West Herr Lincoln
2601 Millersport Highway
Amherst, NY

Addendum 2
May 03, 2021
Page 1 of 8

ID-1
 EQUIPMENT PLAN WITH
 BRANDING REQUIREMENTS
 BID & PERMIT SET
 DRAWN BY: LTS
 SCALE: 1/8" = 1'-0"
 DATE: APRIL 15, 2021

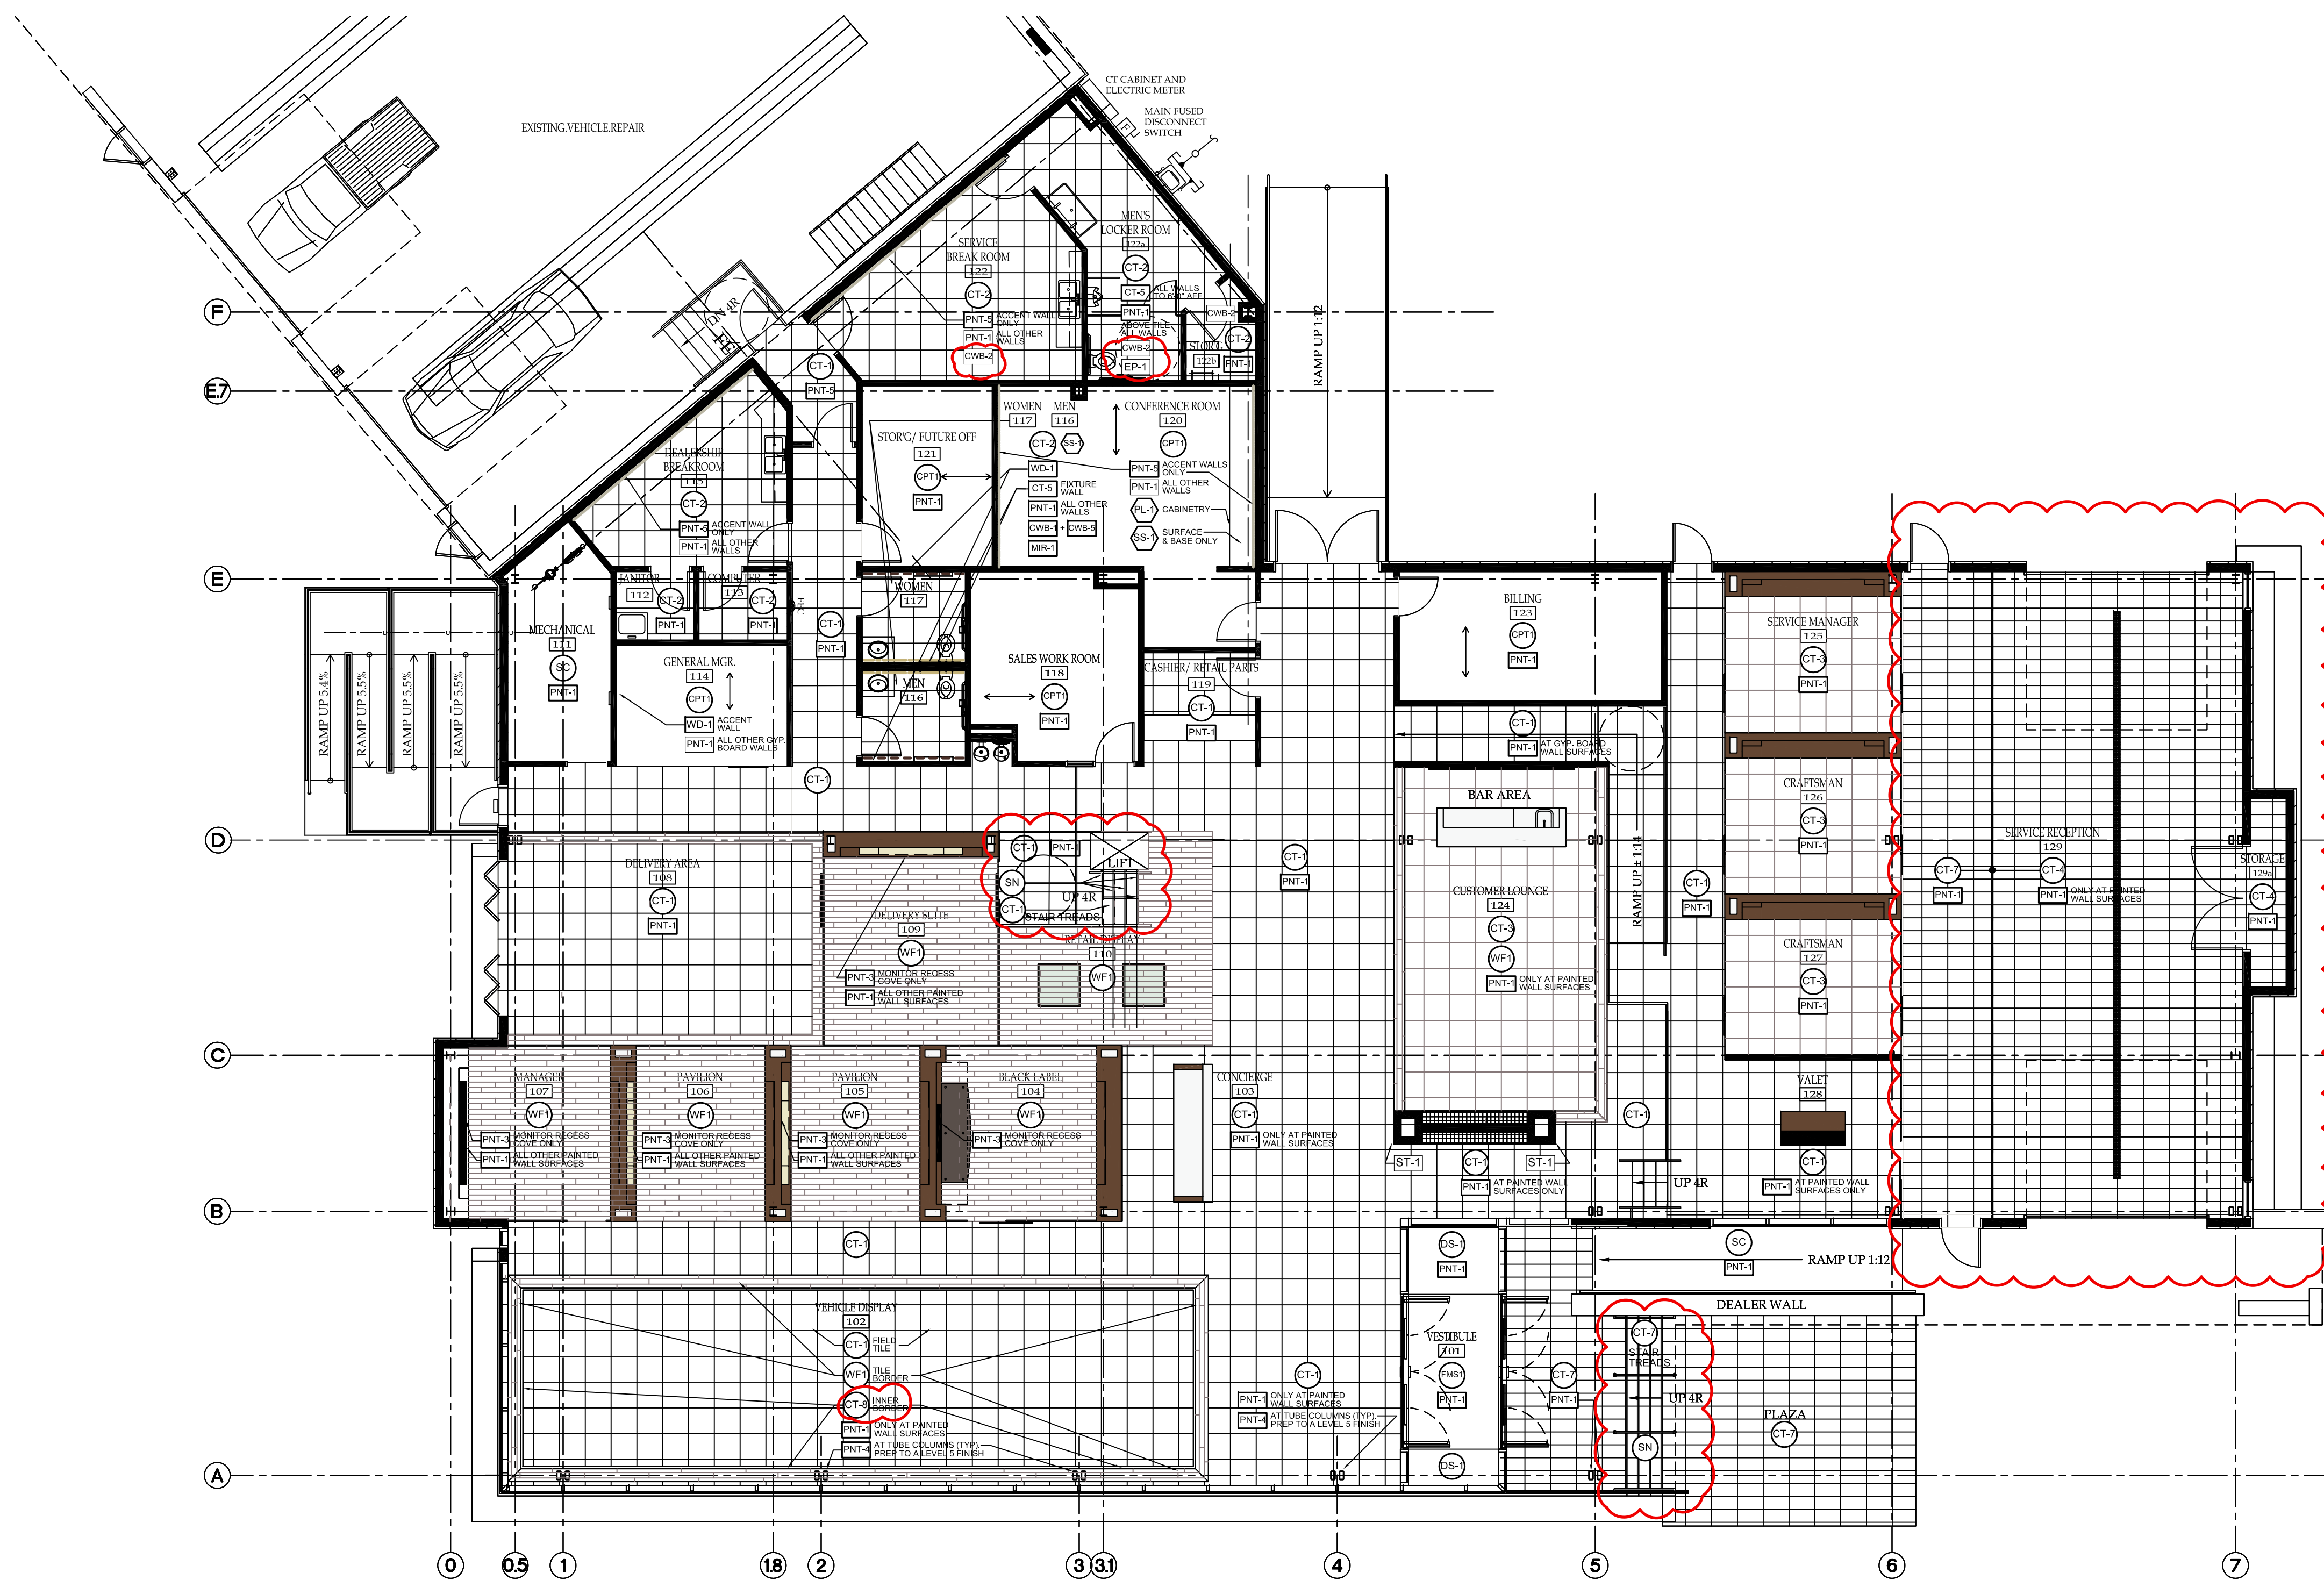
29. ID-1 – LV514 states quantity (1) YES: 1 IN 125. However this is listed in rooms 107 and 125. Is this mislabeled? YES. Possibly LV502? NOW LABELED LV5-- IN 107.

30. ID-1 – LV504 – number not being found. Maybe just over looking this? YES. REFER TO ELEVATION J IN DELIVERY SUITE 109 ON DWG. ID-1.
31. Is there a spec. for the ceilings? YES. REFER TO THE MISCELLANEOUS SECTION OF FINISH SCHEDULE ON DWG. ID-2: ACOUSTICAL CEILING.

36. What finish and type of schluter for top of wall tile in mens locker room? REFER TO SPECIFICATION IN INTERIOR DESIGN QUESTION 4d. ABOVE.
37. Reference new Wall System Schedule on ID-1 – Please provide material specifications for the TX-1 vinyl mentioned in the wall finishes section. NOW REVISED TO FWP-1

40. Reference revised drawing ID-1 – The Wall System notes say to provide a separate quote for all new wall systems. Please confirm these items should be priced as an alternate to the bid. In addition please revise the Bid Form to include a space for the alternate pricing. THESE WALL MILLWORK UNITS SHALL BE PART OF THE BASE BID. A SEPARATE LINE ITEM HAS BEEN MADE AVAILABLE ON THE FORM OF BID PROPOSAL: IN THE BID BREAKDOWN SECTION, TO DENOTE ALL OF THE COSTS ASSOCIATED WITH THE MILLWORK WALLS AS DETAILED ON DWG'S. ID-3 AND ID-4.

41. Reference revised drawing ID-1 – The New Wall System between rooms 106 & 107 shows flooring WF1 underneath it. However all other New Wall Systems do not show flooring below. Please advise if flooring to be installed under New Wall Systems. YES. FLOORING IS REQUIRED TO BE INSTALLED BENEATH ALL NEW MILLWORK WALL SYSTEMS.

SECTION 10
SCALE: 3/4" = 1'-0"

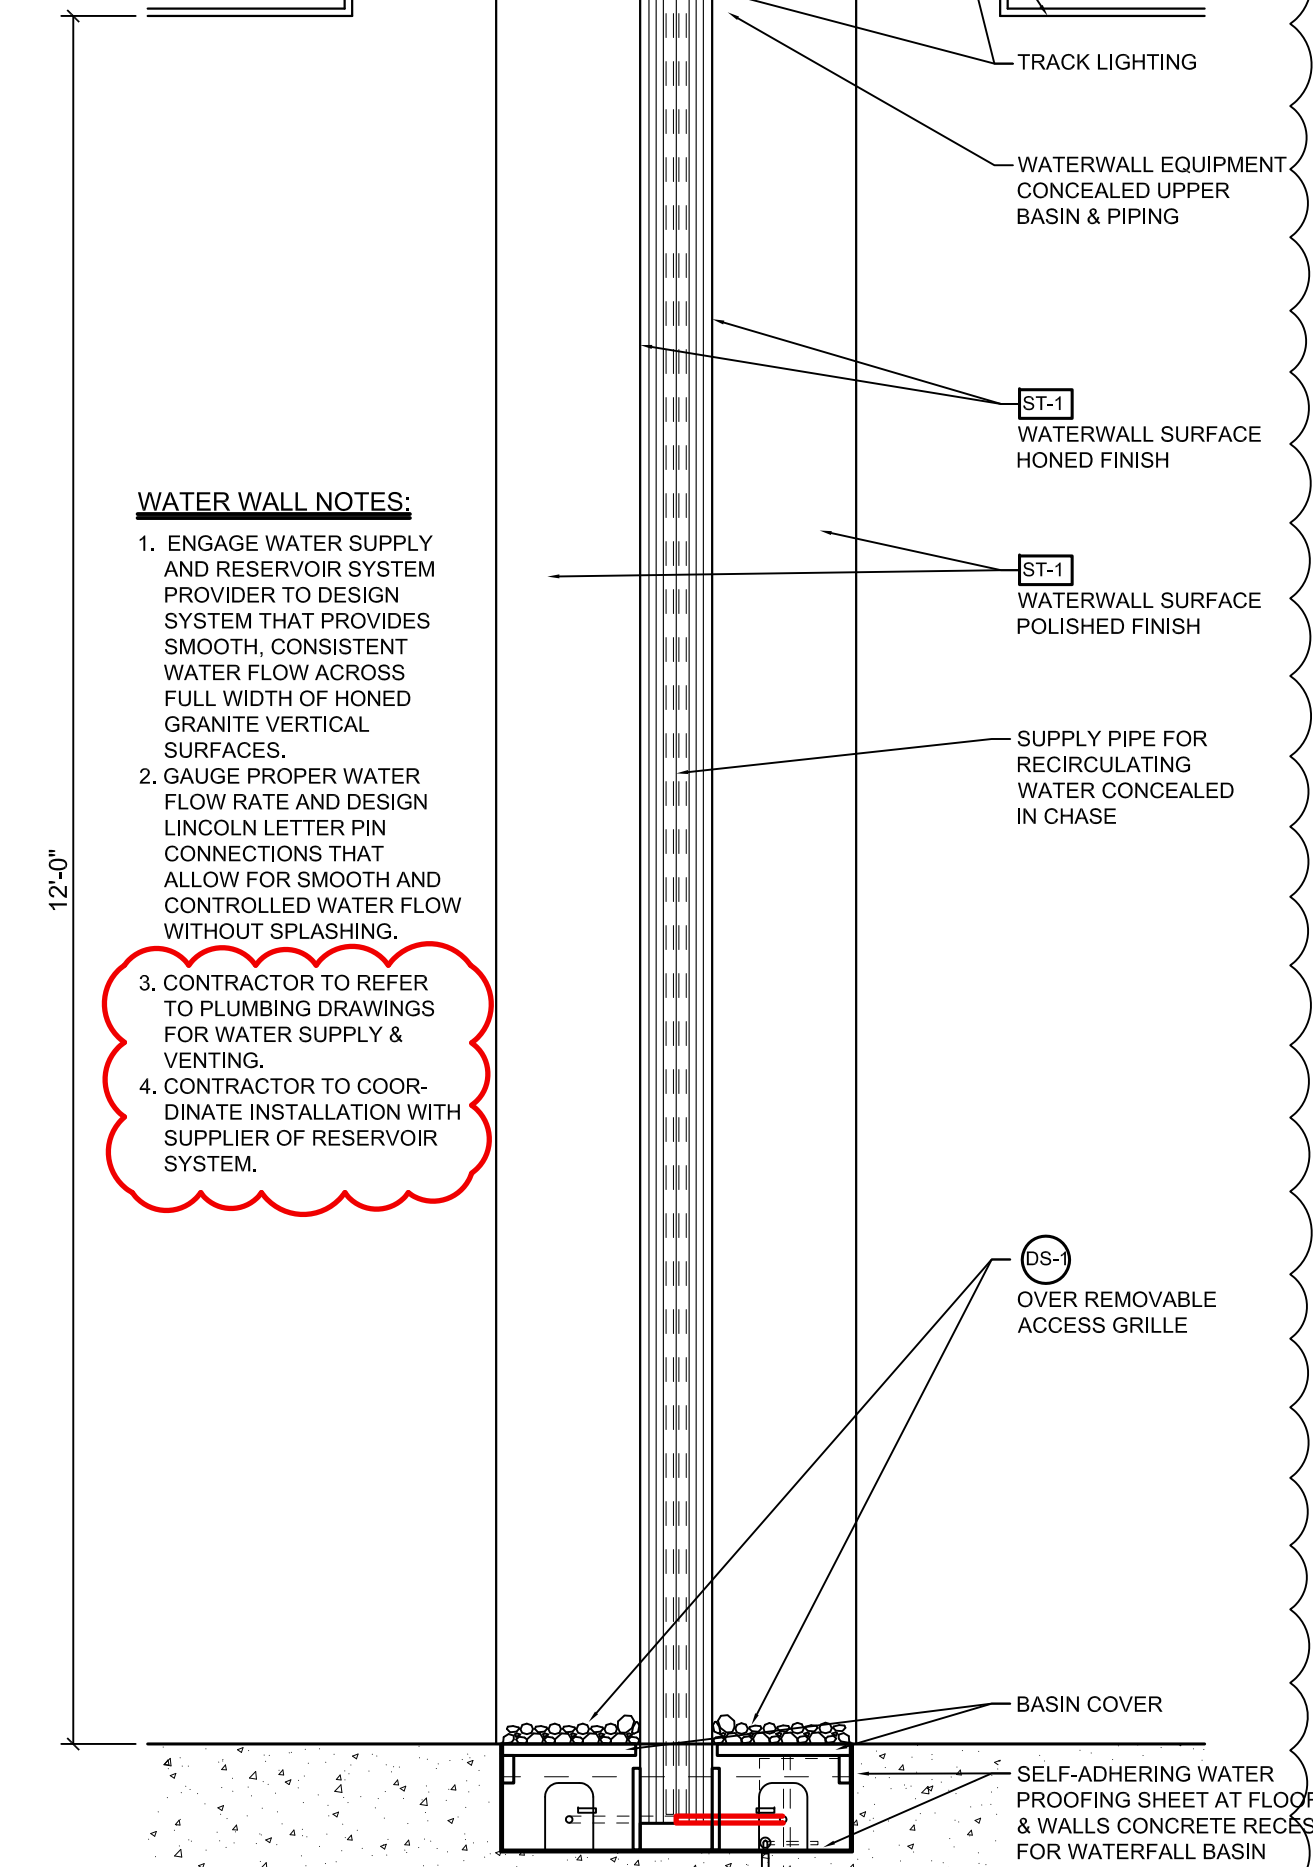
28. Per revised drawings ID-1 you state to include plumbing in the alternate price for the waterwall/millwork. What work does this entail on the GC's end? Would the owner's selected plumber include this work? Is there a specification for the waterwall? **SHOULD BE PART OF THE PLUMBING SCOPE. SECTION 10 IS SHOWN ON ID-4.**

42. Reference 10/ID-4 from the revised ID set – Water Wall notes mention reservoir system provider. Please provide a basis of design for the Water Wall System.
Lincoln Recommended Water Wall Supplier - Please contact:
Midwest Tropical Inc.
Michael W. Burnett
Vice President of Sales and Marketing
3420 W. Touhy Ave.
Skokie, IL 60076
Voice - 847.679.6666
Fax - 847.679.6669
Email - MICHAEL@MIDWEST-TROPICAL.COM
